**ADDENDUM NO. 3 TO ALL BIDDERS:**

Invitation to Bid: **ITB No. SOL1254**

Description: **Public Works Service Center and Fire Stations 4 & 6 Fueling Improvements**

**ATTACHMENT A TO ADDENDUM NO. 3  
TO  
ITB NO. SOL1254  
PUBLIC WORKS SERVICE CENTER AND FIRE STATIONS # 4 & 6 FUELING IMPROVEMENTS  
REVISED DRAWINGS**

SHEET NUMBER:  
C301-PW

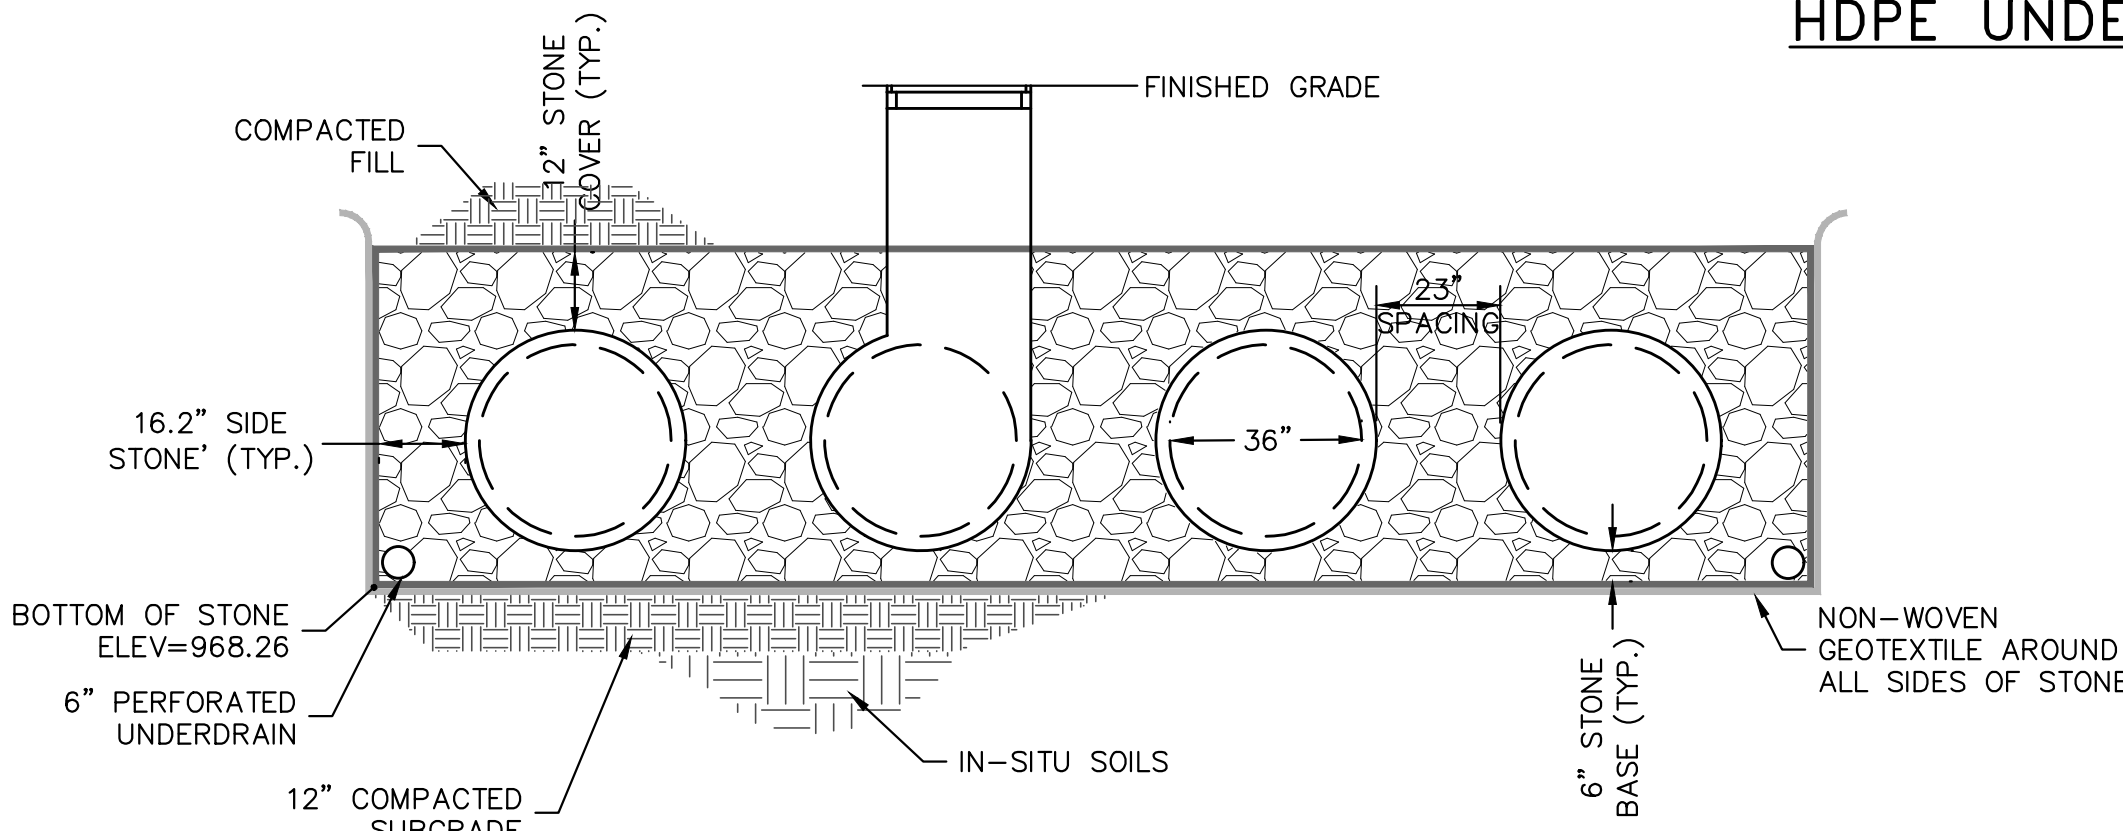
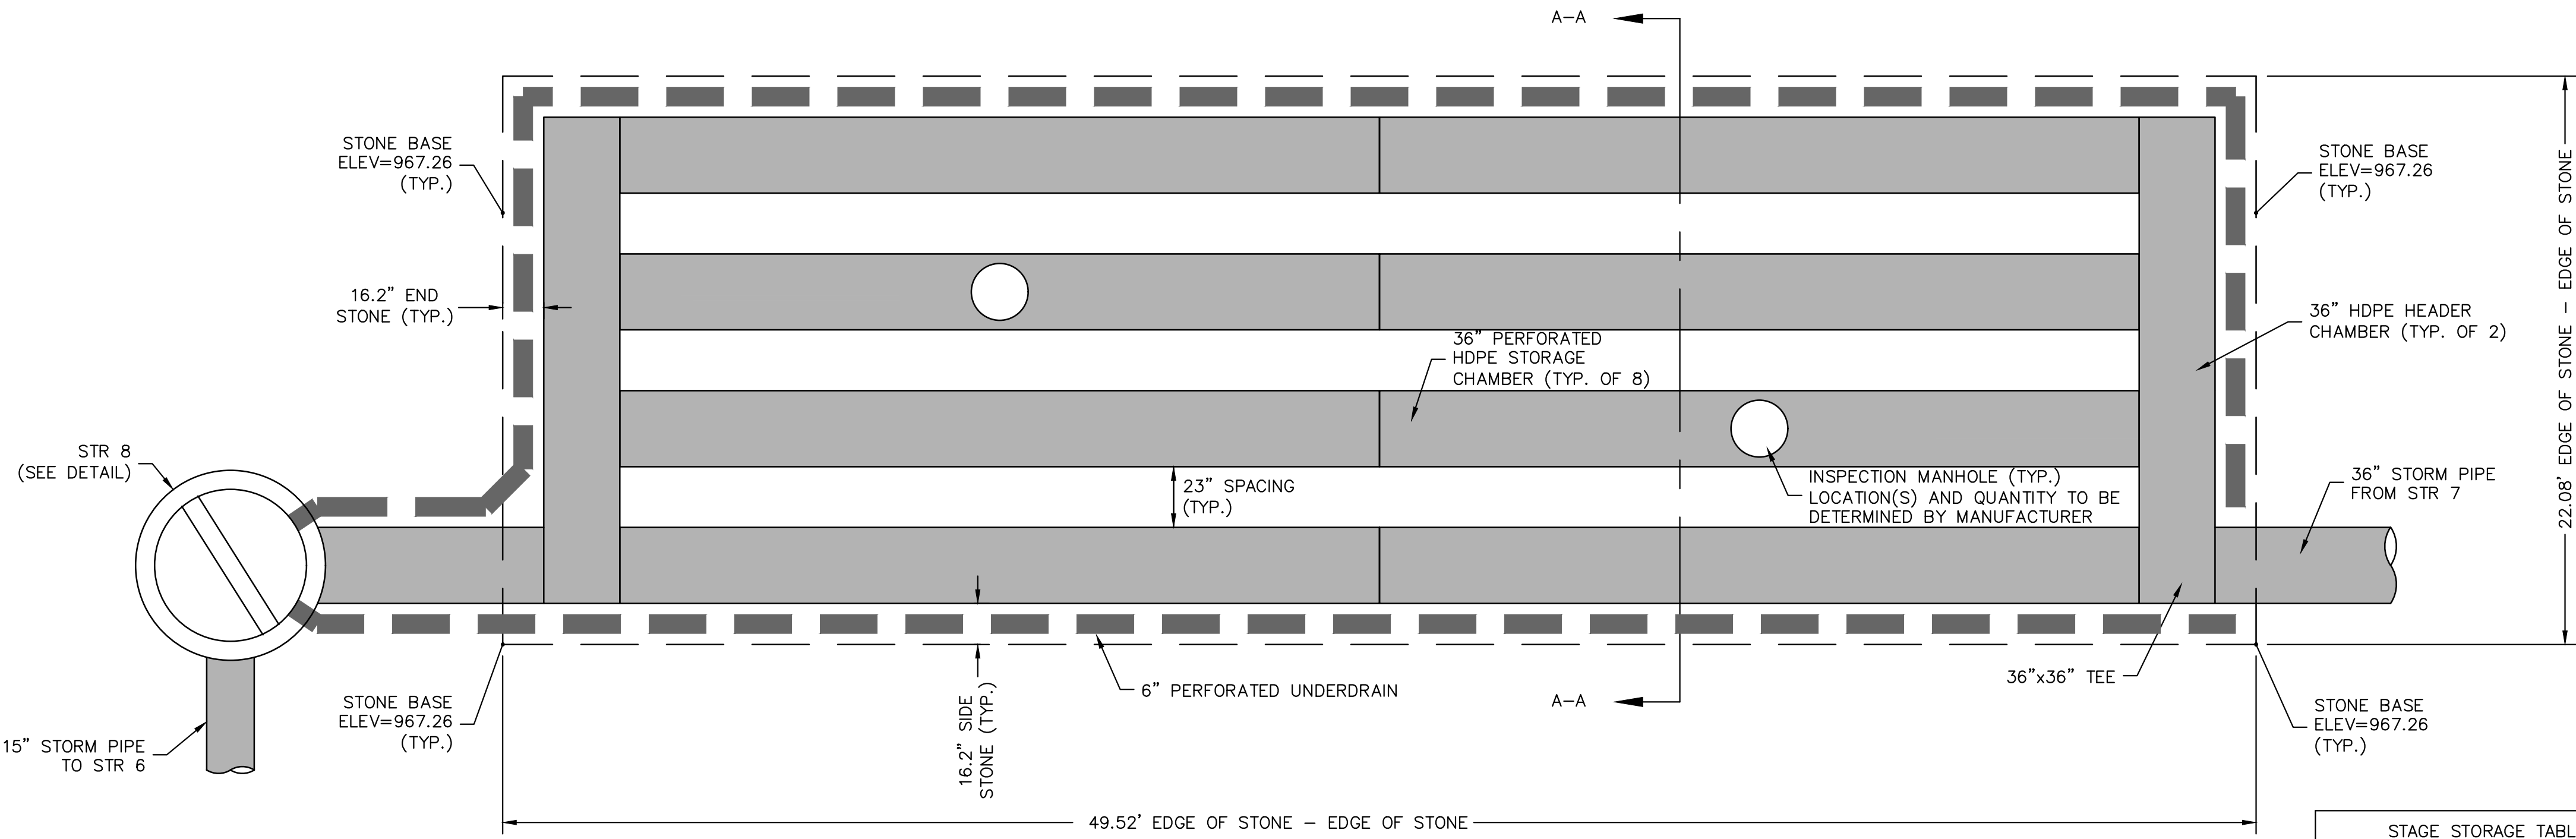
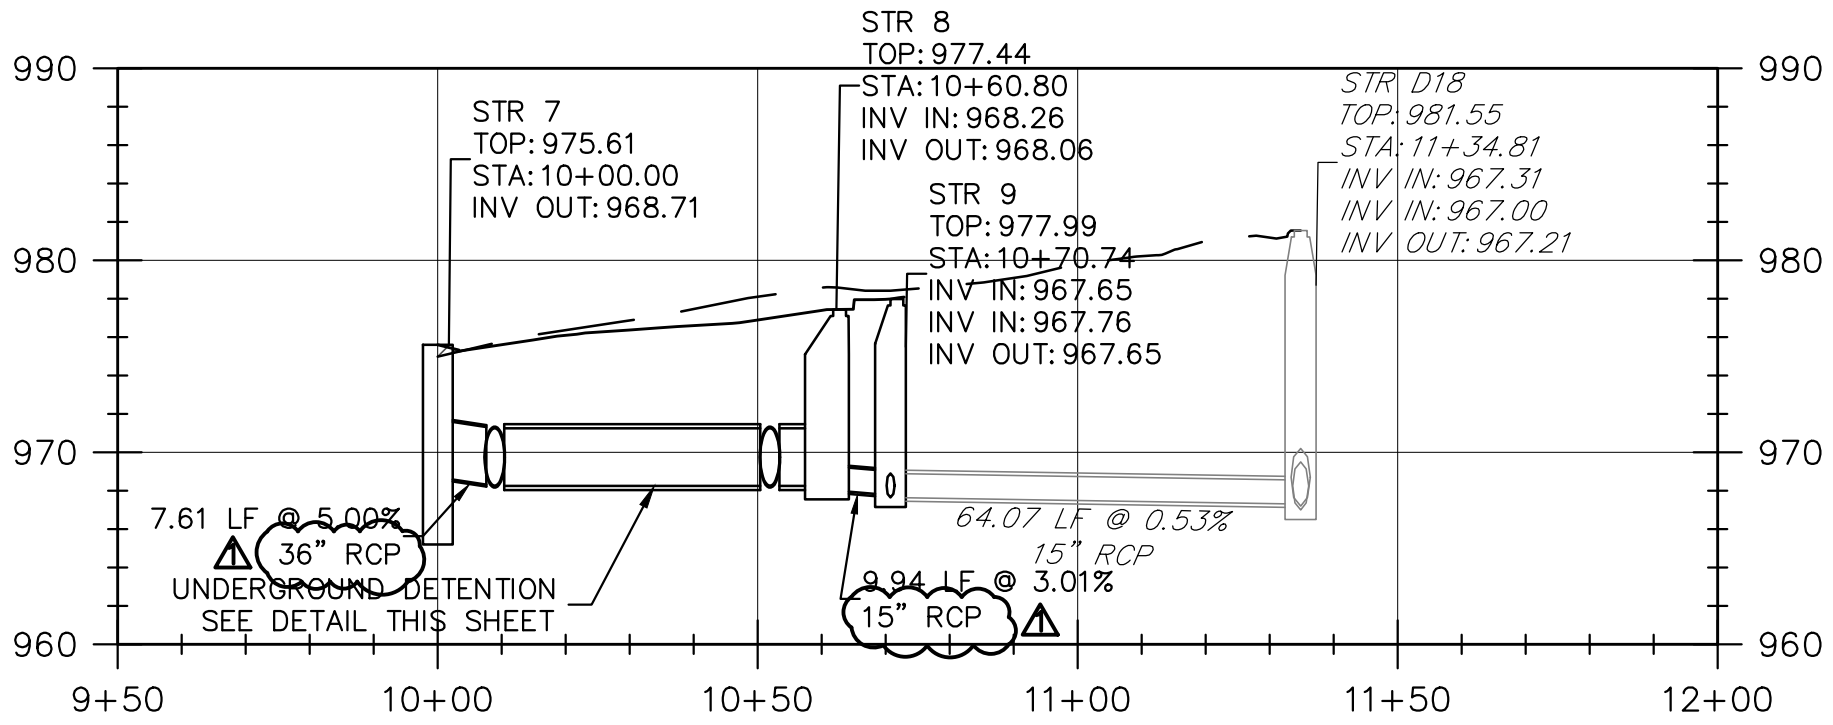
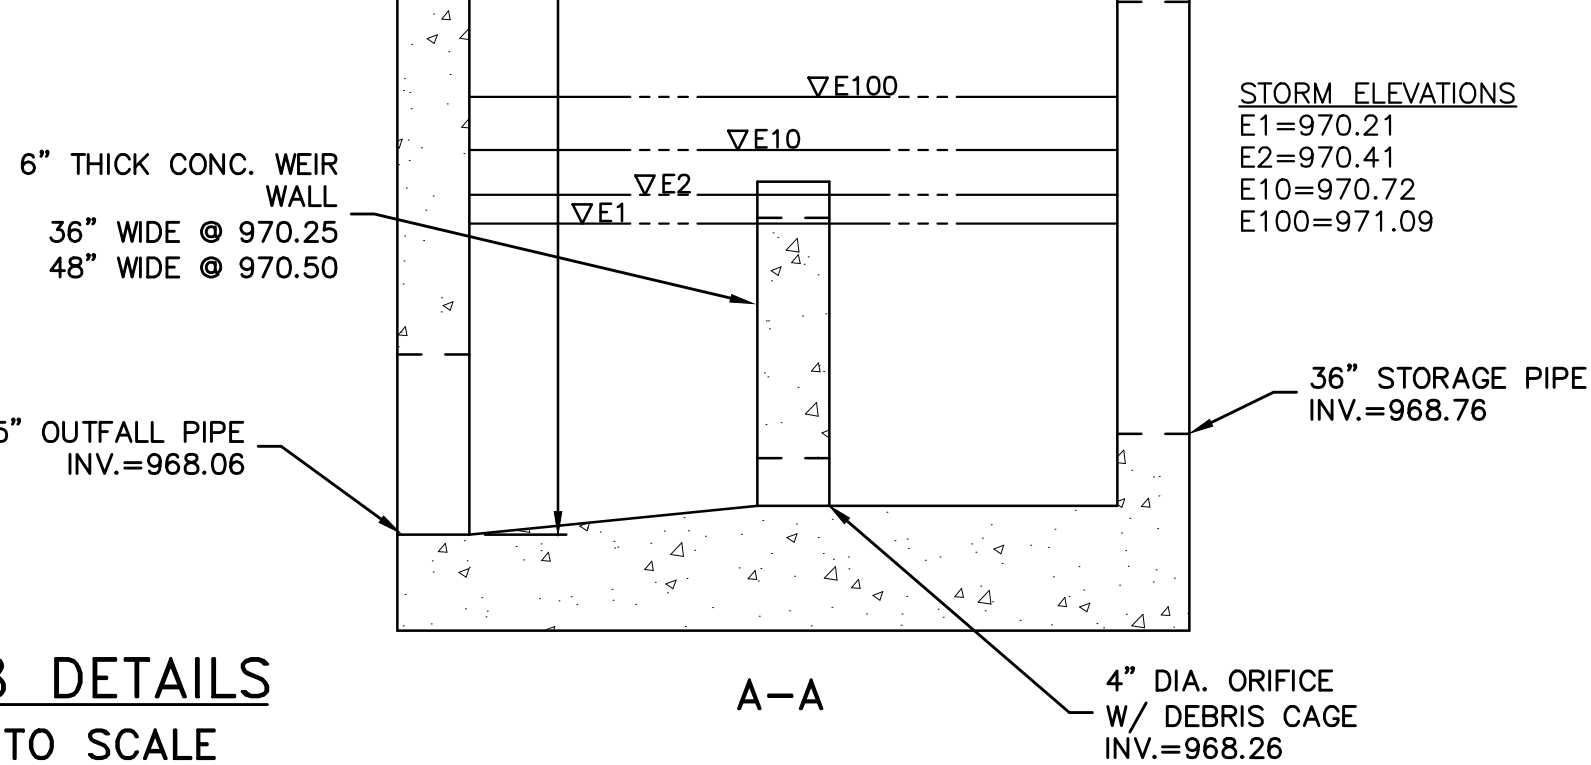
<b>Drawing</b>	<b>Revision</b>
C301-PW – STORM SEWER PROFILES & STORMWATER MANAGEMENT PLAN	Piping materials changed to RCP.
C101-FS6 – DIMENSIONAL LAYOUT & UTILITY PLAN	Additional CG-2 is proposed along edge of pavement at southern entrance of lot.
C501-FS6 – SITE DETAILS	Added flush curb subsection under curbing detail 5.

- 72" DOGHOUSE MANHOLE, TOP=974.72, H=16.26'  
18" INV. IN=967.86 (x2)  
4" INV. IN=969.03  
48" INV. IN=958.46  
48" INV. OUT=958.46
- 1 47.47 LF OF 18" RCP @ 1.50%  
INV. UPPER=968.57 INV. LOWER=967.86

- 2 DI=3B, TOP=974.47, H=5.90', L=12'  
15" INV. IN=968.82  
18" INV. OUT=968.57
- 3 231.55 LF OF 15" RCP @ 1.00%  
INV. UPPER=971.43 INV. LOWER=968.82
- 4 48" MANHOLE, TOP=978.72, H=7.59'  
15" INV. IN=971.23  
15" INV. OUT=971.13

- 5 50.27 LF OF 15" RCP @ 1.00%  
INV. UPPER=971.74 INV. LOWER=971.23
- 6 DI=3C, TOP=976.68, H=4.94', L=4'  
15" INV. OUT=971.74
- 7 DI=3C, TOP=973.97, H=5.54', L=16'  
15" INV. OUT=968.43

- 8 38.52 LF OF 18" RCP @ 1.50%  
INV. UPPER=968.43 INV. LOWER=967.86
- 9 NOT USED
- 10 SWM WATER QUALITY DEVICE  
SEE DETAIL SHEET C302-PW
- 11 SWM 7.61 LF OF 36" TYPE 'S' HDPE @ 5.00%  
INV. UPPER=968.71 INV. LOWER=968.33
